TECHNICAL BULLETIN

[Issue No.] T08-0014

[Title] Restrictions for CC-Link/LT system wiring

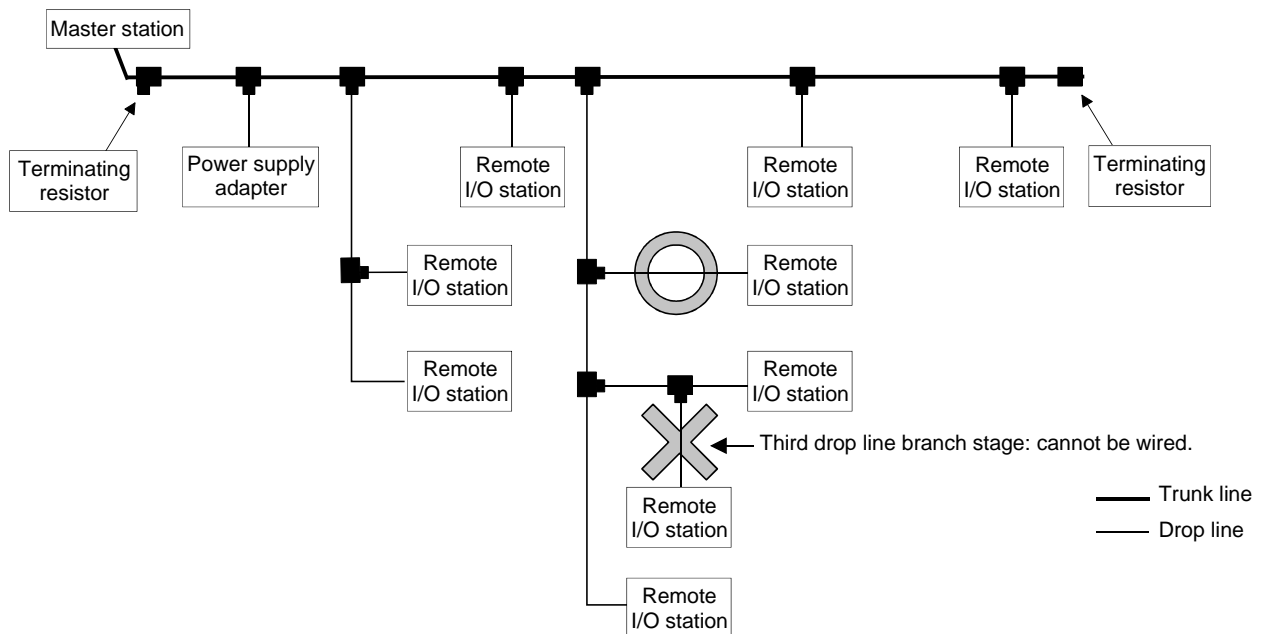
The number of drop line branch stages, within the CC-Link/LT system, is restricted as follows. (Also, this is applicable to systems consisting of AJ65SBT-CLB CC-Link - CC-Link/LT bridge module and CC-Link/LT remote module).

The drop line branch in the CC-Link/LT system can only be subdivided into two stages. Therefore, a third stage in the branch is invalid, as show in the diagram below.
